INBOARD PROFILE

MARINETTE MARINE CORP. MARINETTE WI 54143	SIZE H	FSCM NO. 81340	DRAWING NO. 240-WLBB-601-001	REV H
MMC DWG NO. 0601-601-001	SCALE 3/16"=1'-0"	8.56 SQ FT	SHEET 3 of 7

USCG DWG NO. 240-WLBB-601-001 SHT 3 REV H

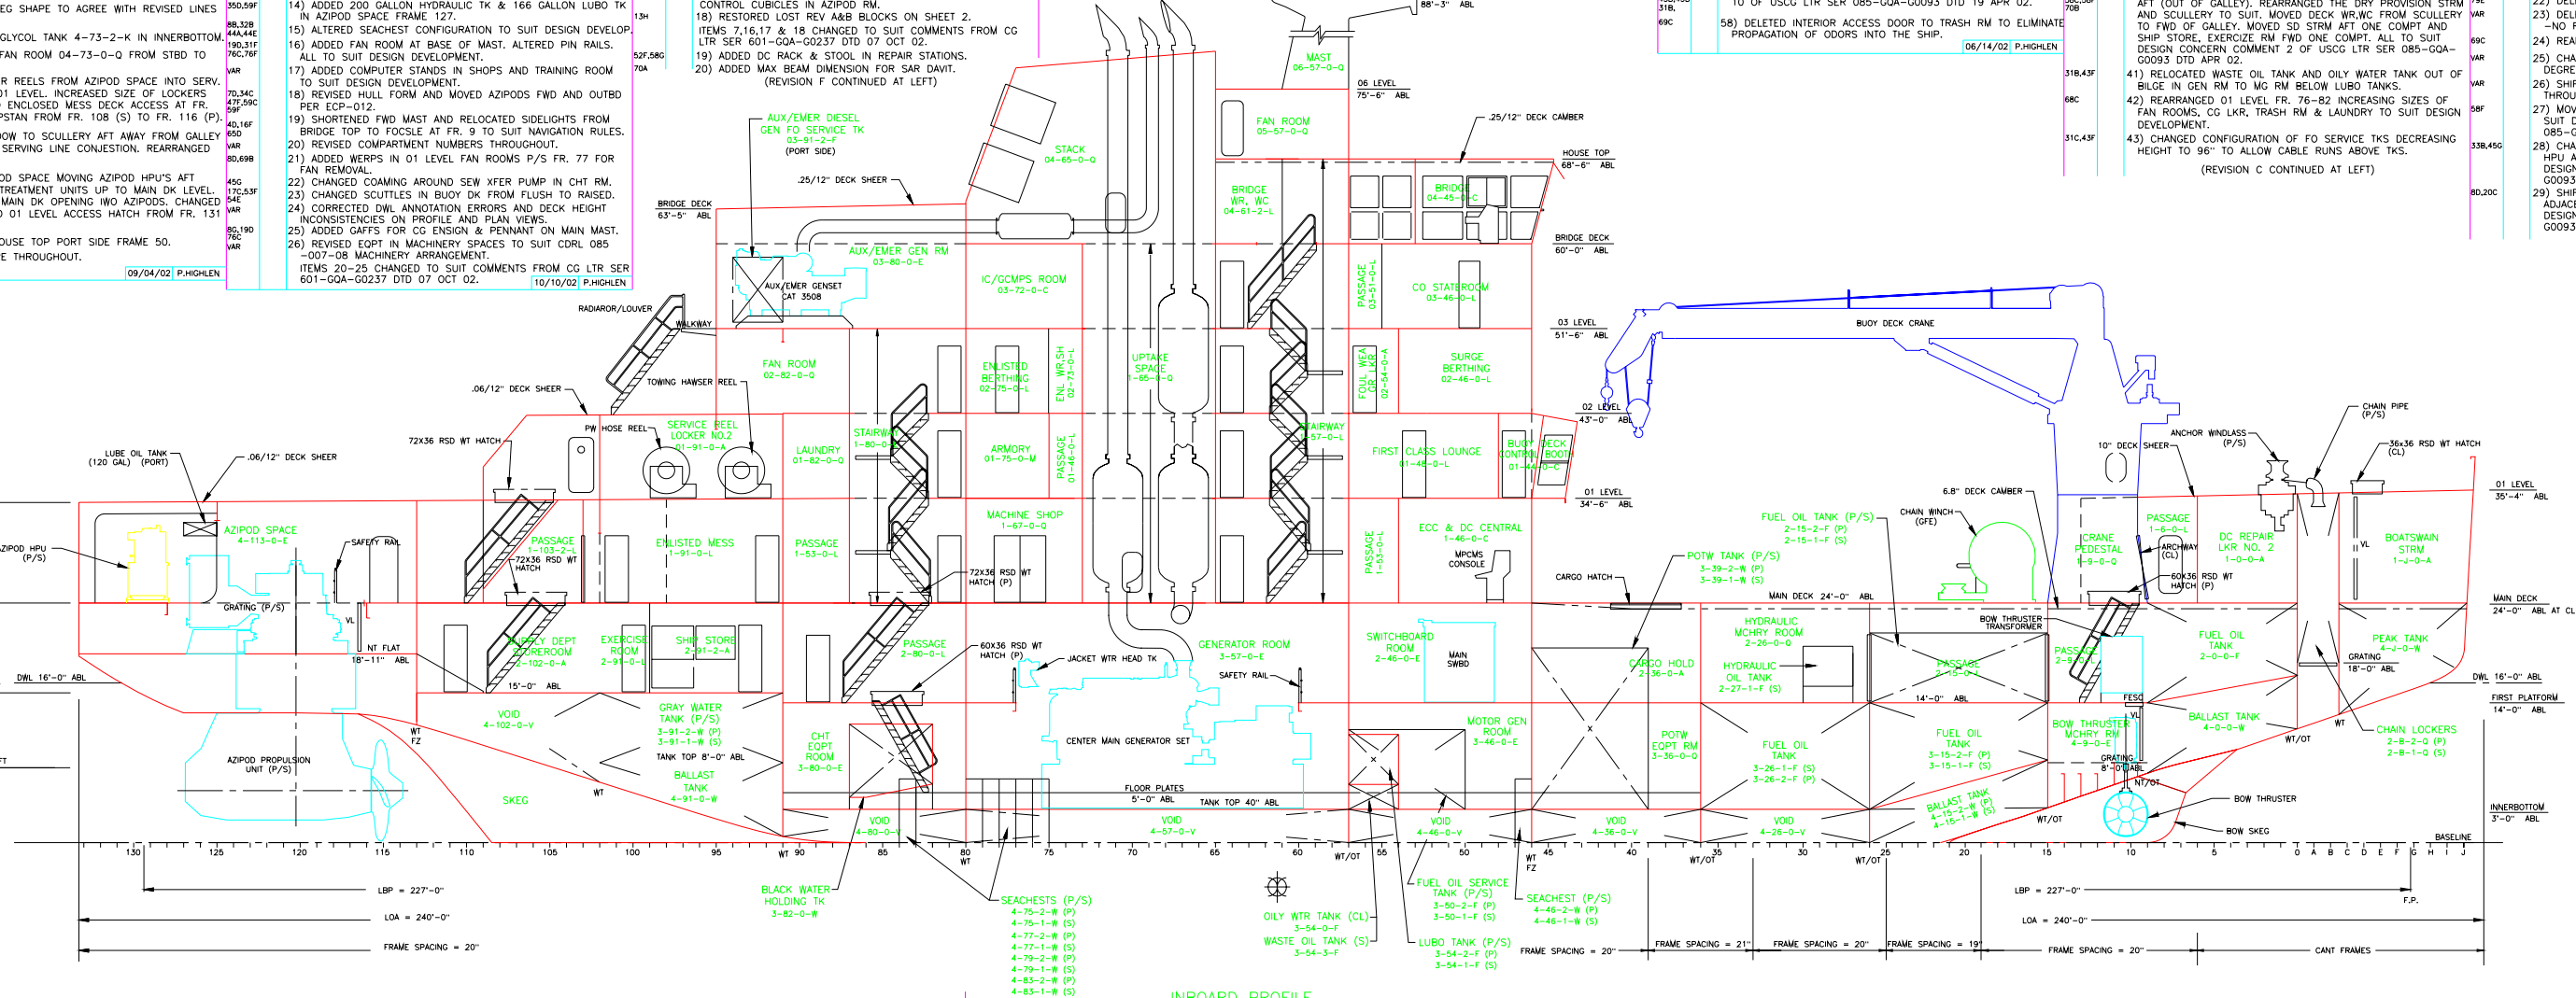
ZONE	REV.	DESCRIPTION	DATE	APPROVED
4D,5C 10D,16D 22C,64C 70B	D	1) DELETED BITTS AT FR. 11 AND THEIR ASSOCIATED CHOCKS. REORIENTED BITTS AT FR. 0. MOVED BITTS FROM FR. 108 TO FR. 113 FOR HEAVY WEATHER MOORING. ADDED 12 X 6 CLOSED CHOCKS AT FR. -3 FOR VOSS STAYS. CHANGED SIZES OF BITTS SHIPWIDE TO AGREE WITH THE MOORING STUDY.		
57F		2) MOVED DECK WR,WC SERVING THE MESS DECK FROM CL TO PORT TO OPEN UP PASSAGE BY WARDROOM.		
55G		3) MOVED LAVATORY OUTSIDE OF MED TREATMENT WR & SHOWER ROOM, SPACE IS TO SMALL TO ACCOMMODATE LAV.		
57E		4) RELOCATED ESCAPE SCUTTLE IN MAIN DK FROM FR. 101 (CL) TO FR. 92 STBD.		
57G		5) REMOVED SECTION OF TRANSVERSE BHD AT FR. 91 PORT SIDE TO OPEN ACCESS TO ENLISTED MESS.		
57F		6) REVISED GALLEY ARRANGEMENT TO SUIT FULL SCALE MOCK-UP COMMENTS. CHANGED MESS TABLE DESIGN, AND ADDED PASS WINDOW BETWEEN GALLEY AND WARDROOM.		
55G		7) REVISED CHANGE ROOM ARRANGEMENT TO SUIT FULL SCALE MOCK-UP COMMENTS. CONVERTED OUTBD SHOWER ROOM INTO A WR,WC.

32C,56A		8) RAISED FIRST PLATFORM IN GEN RM FROM 14'-0" TO 15'-0" ABOVE BASELINE.		
33B,46C		9) CHANGED VOIDS 4-91-1-V & 4-91-2-V INTO BALLAST TKS.		
7F,19E 31F,75F 79F		10) ALTERED SHAPE OF BRIDGE WINGS AFT AND SIDE BHDS TO IMPROVE VISIBILITY. CHANGED BRIDGE WINDOWS TO SUIT. ALSO MOVED LIFE RAFTS FROM BRIDGE TOP TO 01 LEVEL AFT.		
8F,20E 32F,77F		11) INCREASED SIZE OF STACK TO ACCOMMODATE EXHAUST FANS.		
69B,69F 81B		12) ADDED GALLEY EXHAUST ABOVE 01 LEVEL AT FR. 90.5 STBD.		
5B,28B 41C		13) CHANGED BOW SKEG SHAPE TO AGREE WITH REVISED LINES PLAN (REV. B).		
44C		14) ADDED ETHYLENE GLYCOL TANK 4-73-2-K IN INNERBOTTOM.		
8E,80G		15) MOVED DOOR TO FAN ROOM 04-73-0-Q FROM STBD TO PORT SIDE.		
10D,21D 34D,59F 70C		16) MOVED (3) HAWSER REELS FROM AZIPOD SPACE INTO SERV. REEL LOCKERS ON 01 LEVEL. INCREASED SIZE OF LOCKERS TO SUIT, AND ADDED ENCLOSED MESS DECK ACCESS AT FR. 108. RELOCATED CAPSTAN FROM FR. 108 (S) TO FR. 116 (P).

58F		17) MOVED PASS WINDOW TO SCULLERY AFT AWAY FROM GALLEY ACCESS TO RELEIVE SERVING LINE CONJESTION. REARRANGED SCULLERY TO SUIT.		
22D,35C 59D,59F 71C		18) REARRANGED AZIPOD SPACE MOVING AZIPOD HPU'S AFT AND BEARING LUBE TREATMENT UNITS UP TO MAIN DK LEVEL. INCREASED SIZE OF MAIN DK OPENING IWO AZIPODS. CHANGED LADDERS AND MOVED 01 LEVEL ACCESS HATCH FROM FR. 131 TO FR. 117.		
19F,75G		19) ADDED VDR ON HOUSE TOP PORT SIDE FRAME 50.		
VAR		20) REVISED FURNITURE THROUGHOUT.	09/04/02	P.HIGHLEN

ZONE	REV.	DESCRIPTION	DATE	APPROVED
4D,7D 11D,15D 19C,23D 32D,45G 69C 9F,21C 33E,81C 81F	E	1) ADDED .50 CAL. GUN MOUNTS AT FR -5, 54 & 130. ADDED ARMORY ON 01 LEVEL AND INCREASED AMMO STOWAGE IN MAGAZINE. ALL TO SUIT ECP-002.

2) ADDED LENGTH AND HEIGHT TO AUX/EMER DIESEL GENERATOR ROOM TO ACCOMMODATE CAT 3508 GENSET. ALSO REARRANGED SPACE, AND REDUCED HEIGHT OF STACK.		
69G		3) ADDED LENGTH TO FAN ROOM ON 02 LEVEL TO SUIT ITEM 2 ABOVE.		
80F		4) DELETED FAN ROOM AFT OF STACK ON 04 LEVEL. ADDED AIR HANDLER FOR BRIDGE IN BASE OF MAST.		
9D,21D 70G,81B 81E		5) ALTERED WALKWAY ACCESS AROUND AFT END OF DECKHOUSE TO SUIT ITEM 2 & 3 ABOVE.		
8F,19D 80E 58B		6) ADDED WEAT DOOR ON STBD SIDE OF BRIDGE.

7) ADDED REFR COMPRESSOR ROOM FIRST PLATFORM FR. 102 -113 STBD SIDE. MOVED REFR COMPRESSORS FROM AMR INTO THIS SPACE.		
69C		8) ADDED INTERIOR DOOR ACCESS TO TRASH ROOM PER USCG REQUEST.		
9E,69C 69H,81D		9) RENAMED SUPPLY FAN ROOMS NO. 1 & 2 ON 01 LEVEL AS "FAN ROOMS". RENAMED SUPPLY DUCT AT CORNERS OF HOUSE AS "INTAKE AIR TRUNKS" AND MADE THEM INTEGRAL WITH HOUSE STRUCTURE.		
33B,45G 58A		10) MOVED AFT DECK HPU FROM AMR TO REFR COMPRESSOR RM RENAMED AMR AS CHT EQPT RM.		
7F		11) ADDED NAME BOARD ON OUTBOARD PROFILE.		
16D,18C 20C,22C 54E		12) ALTERED SIZE AND ORIENTATION OF BITTS TO SUIT LATEST MOORING ARRANGEMENT. DELETED BITTS AT FRAME 113.		
44G,55H 56D,56B		13) RELOCATED ESCAPE SCUTTLE IN MAIN DECK, WAS FR. 79 (P). RELOCATED ESCAPE OPENING IN 1ST PLATFORM, WAS FR. 75 (P). RELOCATED AND RESIZED BERP IN MAIN DECK, WAS FR. 79 (S). ALL TO SUIT DESIGN DEVELOPMENT.		
35D,59F		14) ADDED 200 GALLON HYDRAULIC TK & 166 GALLON LUBO TK IN AZIPOD SPACE FRAME 127.

8B,32B 44A,44E		15) ALTERED SEACHEST CONFIGURATION TO SUIT DESIGN DEVELOP.		
19D,31F 76C,76F		16) ADDED FAN ROOM AT BASE OF MAST. ALTERED PIN RAILS. ALL TO SUIT DESIGN DEVELOPMENT.		
VAR		17) ADDED COMPUTER STANDS IN SHOPS AND TRAINING ROOM TO SUIT DESIGN DEVELOPMENT.		
7D,34C 47F,59C 59F		18) REVISED HULL FORM AND MOVED AZIPODS FWD AND OUTBD PER ECP-012.		
4D,16F 65D		19) SHORTENED FWD MAST AND RELOCATED SIDELIGHTS FROM BRIDGE TOP TO FOCSLE AT FR. 9 TO SUIT NAVIGATION RULES.		
VAR		20) REVISED COMPARTMENT NUMBERS THROUGHOUT.		
8D,69B		21) ADDED WERPS IN 01 LEVEL FAN ROOMS P/S FR. 77 FOR FAN REMOVAL.		
45G		22) CHANGED COAMING AROUND SEW XFER PUMP IN CHT RM.		
17C,53F 54E		23) CHANGED SCUTTLES IN BUOY DK FROM FLUSH TO RAISED.		
VAR		24) CORRECTED DWL ANNOTATION ERRORS AND DECK HEIGHT INCONSISTENCIES ON PROFILE AND PLAN VIEWS.		
8G,19D 76C		25) ADDED GAFFS FOR CG ENSIGN & PENNANT ON MAIN MAST.		
VAR		26) REVISED EQPT IN MACHINERY SPACES TO SUIT CDRL 085 -007-08 MACHINERY ARRANGEMENT.

ZONE	REV.	DESCRIPTION	DATE	APPROVED
32B,45F 56B	F	1) LOWERED PLATFORM DECK FR. 57-91 FROM 15' TO 14' ABL TO ALLOW SPACE FOR PROPULSION TRANSFORMERS. INCREASED LENGTH OF BLACK WATER HOLDING TANK TO SUIT.		
44F,56B		2) RENAMED MAIN GEN SETS AS "CENTER", "PORT" & "STBD" PER CG REQUEST.		
5C,29C		3) CHANGED CAMBER IN BUOY DECK DUE TO MIN. OPS DRAFT REQUIREMENT, WAS 5-1/2".		
16E,53G 65D VAR		4) CHANGED EXTERIOR LADDER ACCESSING FOCSLE TO 28" WIDE.

5) ALTERED JOINER LINERS THROUGHOUT TO SUIT DESIGN DEV.		
16E,65C		6) ADDED 36" X 36" WERP ON FOCSLE DK FR. 11 FOR EQUIPMENT REMOVAL.		
9E,21C 81A,81E		7) ADDED FILTER ROOMS 03-80-2-Q & 03-80-3-Q PER DESIGN DEVELOPMENT.		
45F		8) DELETED COAMING IWO BLACK WATER TANK -NO REQUIREMENT.		
57E		9) MODIFIED COOKING EQUIPMENT IN GALLEY COOKING LINE PER CG REQUEST. DELETED FRYERS AND ADDED COMBI.		
57C,33C		10) MOVED LONG. BHD ON PORT SIDE FR. 91-102 FIRST PLTF INBOARD FOR CABLE SEGREGATION. RECONFIGURED SHIP STORE TO SUIT.		
58E		11) RECONFIGURED FREEZE & CHILL STRMS PER DESIGN DEVELOPMENT.		
7F,19D 31E,79F		12) REMOVED SLOPING BHDS P/S IN BRIDGE AND REARRANGED CONSOLE LAYOUT TO SUIT BRIDGE MOCK-UP COMMENTS. ALSO CHANGED WINDOWS.		
79B,79F		13) ADDED STANCHIONS IN BRIDGE AND CO STATEROOM. REARRANGED FURNITURE IN CO STATEROOM TO SUIT.		
42B		14) ADDED TRANSDUCERS IN INNERBOTTOM.		
55H		15) MOVED SHOWER 1-46-4-L OUTBD 40" TO ALLOW FOR DUCT.

VAR		16) CHAMFERED OUTBD AFT CORNERS OF INTAKE AIR TRUNKS AND RENUMBERED AS 01-80-3-Q & 01-80-4-Q, TO IMPROVE WEATHER DECK PASSAGE AROUND BOATS.		
59F		17) REMOVED NOTATION "EMERGENCY CONN STA" FROM AZIPOD CONTROL CUBICLES IN AZIPOD RM.		
13H		18) RESTORED LOST REV A&B BLOCKS ON SHEET 2.		
		ITEMS 7,16,17 & 18 CHANGED TO SUIT COMMENTS FROM CG LTR SER 601-GQA-G0237 DTD 07 OCT 02.		
52F,58G		19) ADDED DC RACK & STOOL IN REPAIR STATIONS.		
70A		20) ADDED MAX BEAM DIMENSION FOR SAR DAVIT.		
		(REVISION F CONTINUED AT LEFT)

ZONE	REV.	DESCRIPTION	DATE	APPROVED
80B	F	21) REARRANGED FURNITURE IN SHIP TRAINING ROOM.		
57F,57H		22) INCREASED SIZE OF TABLES IN CPO & OFFICER'S MESS RMS PER USCG ECR 0022 & 0028.		
56E,56H		23) RELOCATED EQPT IN DC SHOP AND MACH SHOP, AND ALTERED BOUNDARY OF EL SHOP TO SUIT DUCTING.		
53F,70D		24) ADDED MOORING WINCH TRANSFORMERS IN CRANE PEDESTAL AND SERVICE REEL LKR NO.2.		
58B		25) REARRANGED STWG AIDS IN SD STRM TO SUIT ADDED STRUCURAL BRACKETS ALONG BHD 113.		
54A,54D		26) ADDED TRANSFORMER ROOMS 2-36-1-Q & 2-36-2-Q OUTBD OF CARGO HOLD FOR 550KVA TRANSFORMERS. RELOCATED MN DK ESCAPE SCUTTLE FROM OUTBD OF POTWTR TK (STBD) TO INBD PER ABOVE.		
43K,55B 55C		27) REARRANGED SWBD RM & MG RM TO SUIT TRANSFORMER SIZES AND VENT DUCTING. CHANGED INCLINED LADDER ACCESS TO MG RM TO A VERTICAL LADDER.		
6D,67C		28) CHANGED SHAPE OF BUOY DECK CONTROL BOOTH TO IMPROVE VISIBILITY. ADDED HVAC TRUNKS ON FRONT OF HOUSE.

11D,23D 72B,72D		29) ALTERED CONFIGURATION OF MOORING WINCHES TO SUIT VENDOR DESIGN. CHANGED STERN TOW RAIL TO END AT FR.130. MOVED GUN MOUNTS TO TOP OF POST. ALL PER TOWING LINE CLEARANCES.		
55E		30) ENLARGED PASSAGE 1-49-1-L & CO2 LKR 1-46-1-A, AND MOVED DECK WR,WC AFT OF TRANSVERSE PASSAGE. ALL TO SUIT REORIENTATION OF LADDER TO SWBD ROOM.		
68F		31) RENAMED SURGE BERTHING 02-54-3-L AS CPO SR & DELETED SURGE WC,SH 02-60-1-L. PROVIDED LARGER BUNK IN SURGE BERTH 02-46-1-L. ALL PER CG REQUEST.		
30C,54C		32) DELETED SHORE POWER CABLE REEL FROM CARGO HOLD.	03/14/03	P.HIGHLEN

ZONE	REV.	DESCRIPTION	DATE	APPROVED
VAR	C	44) CHANGED FRAME SPACING BETWEEN FR. 19 AND 39 TO ENABLE BHDS 26 & 36 TO FALL ON A FRAME.		
41F		45) MOVED BOW THRUSTER TRANSFORMER TO LOWER LEVEL IN THE BOW THRUSTER SPACE PER DESIGN DEVELOPMENT.		
30B,42G 54D		46) CHANGED SHAPE OF POTW TANKS PER STRUCTURAL CHANGES DELETED INCLINED LADDER AND ADDED VERTICAL LADDER ACCESS INTO POTW EQPT RM.		
40F,52C		47) ENLARGED BALLAST TANKS FR. 0-15, WERE FR. 9-15.		
46B		48) RENAMED BALLAST TANKS 4-91-1-W&4-91-2-W AS VOIDS.		
52E,53C 53F		49) REARRANGED FOCSLE AND ADDED PASSAGE 2-9-2-Q TO SUIT STRUCTURAL CHANGES. ALSO MOVED WELD SLAB AND SURVIVAL SUIT STWG ON BUOY DECK.		
24D,35C 59C,59F		50) ENLARGED MAIN DK OPENING IN AZIPOD RM TO ACCOMMODATE HEIGHT OF AZIPOD RING (1.8M). ALSO STEPPED MAIN DECK FOR HAWSER REELS AND MOVED 01 LEVEL HATCHES INBOARD ABOVE REELS.		
90,21C 69A		51) ADDED BITTS AT FR. 83 ON 01 LEVEL PER MOORING STUDY. MOVED ACCOMMODATION LADDERS FWD TO SUIT.

8G		52) ADDED AIRCRAFT WARNING LIGHT ON MAST.		
52G,59F		53) REDUCED NUMBER OF HAWSER REELS IN BOSN LKR AND AZIPOD ROOM TO SUIT MOORING STUDY.		
28C,52C 52F		54) CHANGED SIZE OF CHAIN LOCKERS AND DELETED RAISED FLOOR PLATES (29'-0" ABL) IN BOSN LOCKER.		
8D,20C 68A,68D		55) MOVED ACCOMM. LADDER FWD AND REVERSED STOWED DIRECTION. ALSO MOVED FIREMAIN SHORE TIE TO DECK EDGE.		
4D,10D 16C,16F 64B,70B		56) CHANGED OLDMAN TYPE CHOCKS TO STANDARD CHOCKS DUE TO USE OF SYNTHETIC LINES.		
7B,9B 43B,45B 31B,		57) ADDED SEACHESTS AT FRAME 46&81 PER DESIGN CONCERN 10 OF USCG LTR SER 085-GQA-G0093 DTD 19 APR 02.		
69C		58) DELETED INTERIOR ACCESS DOOR TO TRASH RM TO ELIMINATE PROPAGATION OF ODORS INTO THE SHIP.	06/14/02	P.HIGHLEN

ZONE	REV.	DESCRIPTION	DATE	APPROVED
69B	C	30) REMOVED GALLEY EXHAUST AT FR. 92 ON THE BOAT DECK. EXHAUST WILL BE ROUTED DURING DETAIL DESIGN. CHANGED PER DESIGN CONCERN COMMENT 9 OF USCG LTR SER 085-GQA-G0093 DTD 19 APR 02.		
16C,64B		31) MOVED ATMS WINCH CONTROLS AFT ON FOCSLE TO IMPROVE VISIBILITY PER DESIGN CONCERN COMMENTS 16 & 17 OF USCG LTR SER 085-GQA-G0093 DTD 19 APR 02.		
20C,80E		32) DELETED GRATING ON BRIDGE WINGS (EXTERIOR) -NO REQUIREMENT.		
22E,70C		33) MOVED P-100 PUMP FROM 02 LEVEL PASSAGE TO SERVICE REEL LKR NO. 2. INCREASED WIDTH OF LKR TO SUIT. CHANGED PER DESIGN CONCERN COMMENT 18 OF USCG LTR SER 085-GQA-G0093 DTD 19 APR 02.		
67B		34) MOVED PHONE SHORE BOX FORWARD PER RECOMMENDED ENHANCEMENT 1 OF USCG LTR SER 085-GQA-G0093 DTD 19 APR 02.		
57B,57E		35) DIVIDED PROPULSION TRANSFORMER ROOM INTO TWO SPACES, AND ADDED AN ESCAPE SCUTTLE IN THE WARDROOM.		
58D		36) CHANGED LONGITUDINAL BHD IN WAY OF SEABAG LKR TO STEEL (A-60).

79F		37) DELETED CLEARVIEW SCREEN ON CL IN THE BRIDGE PER CONTRACT COMPLIANCE COMMENT 5 OF USCG LTR SER 085-GQA-G0093 DTD APR 02.		
22E,30C 54C,70C		38) RELOCATED EL SHORE PWR CABLE REEL FROM SERVICE REEL LKR NO. 1 INTO CARGO HOLD. THIS ALLOWS P/S HANDLING USING THE BUOY CRANE. REDUCED SIZE OF SERVICE LKR TO SAVE WEIGHT.		
VAR		39) ADDED MAJOR VENT DUCTING AND FAN COIL UNITS (FCU)'S THROUGHOUT TO SUIT DESIGN DEVELOPMENT.		
22B,34C 58C,58F 70B		40) RELOCATED STORES HATCH IN THE 01 LEVEL AND MN DK AFT (OUT OF GALLEY). REARRANGED THE DRY PROVISION STRM AND SCULLERY TO SUIT. MOVED DECK WR,WC FROM SCULLERY TO FWD OF GALLEY. MOVED SD STRM AFT ONE COMPT AND SHIP STORE, EXERCIZE RM FWD ONE COMPT. ALL TO SUIT DESIGN CONCERN COMMENT 2 OF USCG LTR SER 085-GQA-G0093 DTD APR 02.		
31B,43F		41) RELOCATED WASTE OIL TANK AND OILY WATER TANK OUT OF BILGE IN GEN RM TO MG RM BELOW LUBO TANKS.		
68C		42) REARRANGED 01 LEVEL FR. 76-82 INCREASING SIZES OF FAN ROOMS, CG LKR, TRASH RM & LAUNDRY TO SUIT DESIGN DEVELOPMENT.

31C,43F		43) CHANGED CONFIGURATION OF FO SERVICE TKS DECREASING HEIGHT TO 96" TO ALLOW CABLE RUNS ABOVE TKS.		
		(REVISION C CONTINUED AT LEFT)

ZONE	REV.	DESCRIPTION	DATE	APPROVED
17C,20C 22F,53E 68D,70A	C	13) MOVED FUEL SHORE TIE STATIONS FROM FWD BUOY DECK TO AMIDSHIPS P/S ON 01 LEVEL. MOVED FIRE MAIN SHORE TIE FROM FR. 58 01 LEVEL TO FR. 81 P/S. MOVED GRAY WATER SHORE TIE FROM BUOY DECK FR. 81 P/S TO 01 LEVEL FR.106. MOVED WASTE OIL/OILY WTR/LO SHORE TIES FROM FR. 107 TO 62 01 LEVEL P/S. ALL TO SUIT DESIGN DEVELOPMENT -THIS ELIMINATED RAISED PLATFORMS FOR CROSS-DECK WINCHES AND REQUIRED ADDITION OF FLAG BLOCKS FWD. MOVED FWD CROSS-DECK WINCHES AFT 50 INCHES.		
57E		14) ELIMINATED REFRIGERATOR, SINK, MICROWAVE AND COFFEE URN FROM WARDROOM -NO REQUIREMENT.		
58F		15) CHANGED ACCESS TO SCULLERY THROUGH THE GALLEY TO IMPROVE ACCESS. REARRANGED GALLEY PER DESIGN DEVELOPMENT AND DESIGN CONCERN COMMENT 14 OF USCG LTR SER 085-GQA-G0093 DTD 19 APR 02.		
5C,17C 53E		16) CHANGED BUOY PORTS TO SAME SIZE/CONFIGURATION AS WLB(B) CLASS.		
21E,81C		17) ADDED EXTERIOR ACCESS DOOR TO AUX/EMER GEN RM PER ABS REQUIREMENT AND SAFETY.

18D,54F		18) DELETED GRIPERS ON BUOY DECK.		
30C,54C		19) MOVED HYDR MCHRY RM AFT ONE COMPARTMENT & FUEL TANKS FORWARD FOR TRIM.		
8F,20E 32D,56F 68C,68F 80C,80F 76F		20) SHIFTED UPTAKE AND STAIRWAY AFT 3 FRAMES TO IMPROVE STRUCTURAL CONTINUITY AND BRIDGE ACCESS BEHIND HELM. MAST AND STACK ALSO MOVED AFT.		
33C,46F 58C		21) MOVED GRAY WATER TANKS AFT AND DELETED COLLECTION TANK IN CHT RM. THIS CAUSED RELOCATION OF THE SD STRM, EXERCISE RM, SHIP STORE, AND SEABAG LKR. ALL PER DESIGN DEVELOPMENT AND DESIGN CONCERN COMMENT 12 OF USCG LTR SER 085-GQA-G0093 DTD 19 APR 02.		
79E		22) DELETED BRIDGE CHAIRS P/S -NO REQUIREMENT.		
VAR		23) DELETED CHAIRS IN STATEROOMS EXCEPT IN WAY OF DESKS -NO REQUIREMENT.		
69C		24) REARRANGED LAUNDRY EQUIPMENT.		
VAR		25) CHANGED INCLINED LADDERS IN MACHINERY SPACES TO 50 DEGREE INCLINATION WHERE POSSIBLE.		
VAR		26) SHIFTED STRUCTURAL BHDS, OPENINGS AND WINDOWS THROUGHOUT TO SUIT STIFFENER AND WEB SPACING.

58F		27) MOVED REFERIGERATION CONTROL OUTSIDE OF SCULLERY TO SUIT DESIGN CONCERN COMMENT 13 OF USCG LTR SER 085-GQA-G0093 DTD 19 APR 02.		
33B,45G		28) CHANGED CHT RM DESIGNATION TO AMR AND MOVED AFT DK HPU AND REFR COMPRESSORS INTO THIS SPACE. ALL PER DESIGN CONCERN COMMENT 3 OF USCG LTR SER 085-GQA-G0093 DTD 19 APR 02.		
8D,20C		29) SHIFTED QUARTERDECK STATIONS FWD AND PASSAGE AFT ADJACENT TO FAN ROOMS TO MITIGATE NOISE EFFECTS PER DESIGN CONCERN COMMENT 7 OF USCG LTR SER 085-GQA-G0093 DTD 19 APR 02.		
		(REVISION C CONTINUED AT LEFT)

ZONE	REV.	DESCRIPTION	DATE	APPROVED
VAR	B	25) REVISED DECK LINES PER DWG 801-001 REV A LINES PLAN. UPDATED AZIPOD PROPULSION UNITS PER LATEST INFORMATION AVAILABLE AND LOCATED THEM PER HULL LINES PLAN.		
45G		26) MOVED AND ENLARGED SMALL ARMS MAGAZINE ON INNER-BOTTOM DUE TO NEW LINES.		
31C,32C 45C,55C 56C		27) ELIMINATED SWBD OPERATOR'S RM IN GENERATOR RM COMPARTMENT. RENAMED MOTOR GEN RM 2-46-0-Q AS SWBD RM AND LOCATED MAIN SWBD IN THIS SPACE. RENAMED AMR 4-46-0-E AS MOTOR GEN RM & MOVED MG SETS INTO THIS SPACE. RELOCATED ACCESS LADDER FROM FR.50 NEAR CENTERLINE TO STBD SIDE, TO ACCOMMODATE SWBD ARRGT. MOVED STARTING AIR FLASKS AFT INTO CHT EQPT RM. MOVED /REARRANGED PUMPS AND EQPT OUT OF AMR TO SUIT NEW ARRGT AS MG ROOM. REASON FOR CHANGE; MAIN GENERATOR SWBD CLEARANCE ISSUES. PROVIDES CLOSER ACCESS BETWEEN ECC & SWBDS AND IMPROVES DC FUNCTIONAL SPACE IN ECC.		
31C,55F 56F		28) MOVED ECC & DC CENTRAL TO STBD SIDE AND BUOY DK CHANGE RM TO PORT. MOVED ENGR/LOG OFFICE & DECK WR,WC TO STBD SIDE AND MED TRTMT RM TO PORT. ALL TO PROVIDE BEST ACCESS FOR THE ECC AND SPACES BELOW.

44F,55A 55D		29) MOVED SPACE RESERVED FOR WORKBENCH & CABINETS FROM LOWER GEN RM AFT TO UPPER GEN RM FWD (P/S) TO ALLOW SPACE FOR ROTOR REMOVAL.		
42F		30) INCREASED SIZE OF (SP & WT) FOR R.O. UNIT IN POTW EQPT RM TO 200 SQ. FT. TO MEET SPEC REQUIREMENT. REARRANGED EQPT IN THE SPACE TO SUIT.		
VAR		31) REMOVED TANK CAPACITIES FROM DWG. CAPACITIES WERE INCORRECT AND DID NOT AGREE WITH CDRL 051-003 AREA/VOLUME REPORT.		
42E,42G 54B,54D		32) CHANGED OUTBOARD SLOPING BOUNDARY IN POTW TANKS. BHD IS VERTICAL IN LEU OF SLOPING. WATER CAPACITY MEETS REQUIRED DURATION.		
9D,21D 69C,69F		33) MIRRORED BOATS SO THAT CBL IS ON STBD SIDE. BOTH BOATS AND DAVITS ARE IDENTICAL TO WLB.		
54C,56G		34) REARRANGED SHOPS ON MAIN DECK AND MOVED DC SHOP FROM FIRST PLTF TO MAIN DECK TO MAKE SPACE FOR FUEL TANKS.		
6C,18D 53E,53H		35) SHIFTED CHAIN WINCH AND BUOY PORTS FWD 20".		
56C,56G		36) REMOVED PORT SIDE INCLINED LADDER ACCESS TO GEN RM. MOVED 72X42 BERP FROM FR. 62 TO 78 INSIDE WORKSHOP. ADDED ESC SCUTTLE FOR SECOND MEANS OF ESCAPE FROM GEN RM.

18C,18F 54E,54H 69A,69D		37) ADDED SEWAGE SHORE CONNECTIONS (P/S) AT FR.85 ON 01 LEVEL. MOVED THE BUOY DECK SHORE CONNECTION FOR GRAY WATER (P/S) TO FR.39.		
44E,44H 55E,56B 69C		38) ADDED HOSE STATIONS SHIPWIDE.		
56A,45E		39) RELOCATED STARTING AIR COMPRESSORS FROM GEN RM TO CHT EQPT RM NEAR FLASKS.		
56A,56D 59E,59H		40) MOVED AZIPOD HPU'S FROM HYDR MCHRY RM NO.2 AFT INTO AZIPOD RM. MOVED A/C PLANTS FROM HYDR MCHRY RM NO.2 FWD INTO GEN RM. ALL TO SUIT ADDITION OF FUEL TANKS AFT. ALSO REARRANGED AZIPOD RM EQUIPMENT ADDING UPPER LEVEL AT MAIN DECK FOR MORE EFFICIENT USE OF VOLUME IN THIS COMPARTMENT.		
57G,58F		41) MOVED MAIN DECK CG LKR FROM FR.90 TO FR.98.		
VAR		42) DEFINED SHEER AND CAMBER ON THE INBD PROFILE.		
8B,32B 44B,44D 44E,44H		43) ALTERED SEACHEST CONFIGURATION, MOVED AFT AND LOWER. SEACHEST CONFIGURATION IS STILL UNDER DEVELOPMENT.		
28C,40F 45C,52C		44) DELETED BALLAST TANKS 4-80-1-W & 4-80-2-W. RENAMED BALLAST TANK 4-0-0-W AS UNASSIGNED TANKAGE.

32B,44C 45F,56C		45) RELOCATED WASTE OIL TANK & OILY WATER TANK INTO BILGE IN GENERATOR RM TO PROVIDE GRAVITY DRAINAGE TO TANKS. MOVED GENSETS AFT & REARRANGED EQPT IN LOWER LEVEL OF GEN RM AND CHT RM TO SUIT. ALTERED GEN SETS TO DEPICT AIR COOLED GENERATORS.		
67C,68D		46) MOVED 01 LEVEL CG LKR FROM FR.51 TO FR.81. RELOCATED SMALL ARMS LKR FROM FR.79 TO FR.50 AND ADDED SPACE RESERVATION FOR FUTURE 50 CAL GUN STWG.		
7F,19E 76G		47) REVISED TOPSIDE ANTENNA ARRANGEMENT.		
42E		48) ADDED BROMINE CARTRIDGE LOCKER IN POTW EQPT RM.		
55F		49) ADDED PORTABLE BROW ON FRONT OF HOUSE.		
57F		50) INCREASED SIZE OF OFFICERS MESS TABLE.		
52F,60F		51) SHOWED (3) HAWSER REELS IN FWD BOSN STRM AND (4) HAWSER REELS IN THE AZIPOD RM.		
31B,34C 55A,55E 58A,58E		52) DEPICTED MAIN VERTICAL FIRE ZONE BOUNDARIES AT FR. 46 & 113.		
52E,69C		53) ADDED HOSE STWG FOR SEWAGE, HYD OIL, WASTE OIL/OILY WTR AND LUB OIL.	03/12/02	P.HIGHLEN

ZONE	REV.	DESCRIPTION	DATE	APPROVED
55B	C	1) MOVED 1500 KVA TRANSFORMER TO STBD SIDE IN SWBD RM FOR SURVIVABILITY. REDREW NEUTRAL POINT RESISTORS TO ACTUAL SIZE.		
29C,42F 53C		2) CHANGED FUEL TANKS FR. 0 TO 36 FOR PRODUCIBILITY AND VESSEL TRIM.		
69B		3) RECONFIGURED TRASH RM ADDING STWG FOR TRASH BALES AND A CAN CRUSHER PER DESIGN DEVELOPMENT AND DESIGN CONCERN COMMENT 19 OF USCG LTR SER 085-GQA-G0093 DTD 19 APR 02.		
90,21E 69B,69G 81B,81G		4) MODIFIED SUPPLY DUCTS ON AFT END OF HOUSE FROM INDEPENDENT DUCTING TO INTRIGAL WITH STRUCTURE PER CONTRACT COMPLIANCE COMMENT 8 & ENHANCEMENT COMMENT 2 OF USCG LTR SER 085-GQA-G0093 DTD 19 APR 02.		
90,21D 69B,69E		5) ADDED POSTS AT FR.91 & 93 FOR BUMPERS IN WAY OF SAR BOAT, ALSO GUARDS EMBARKATION LADDER TO SAR.		
23E,71C		6) MOVED TOWING PADEYES ON AFT DECK FROM FR.125 TO 122.		
22D,58F 70B		7) CHANGED SIZE AND ORIENTATION OF STORES HATCH FOR STANDARD 48X40 PALLET, PER FINDINGS OF CDRL 052-003-03

7E,67E 67H,75E 19C		8) RELOCATED LIFE RAFTS FROM 02 LEVEL TO TOP OF HOUSE.		
59B		9) ADDED AZIPOD BEARING LUBE TREATMENT UNITS IN LOWER LEVEL OF AZIPOD SPACE.		
59F		10) CHANGED SIZE AND ORIENTATION OF AZIPOD HPU'S & CONTROL CUBICLES IN UPPER LEVEL OF AZIPOD SPACE.		
43F		11) MOVED L.O. PUMP FROM MG RM INTO GEN RM.		
55E		12) MOVED DECK WR, WC ON MAIN DECK STBD FROM FR. 58 TO FR. 52.
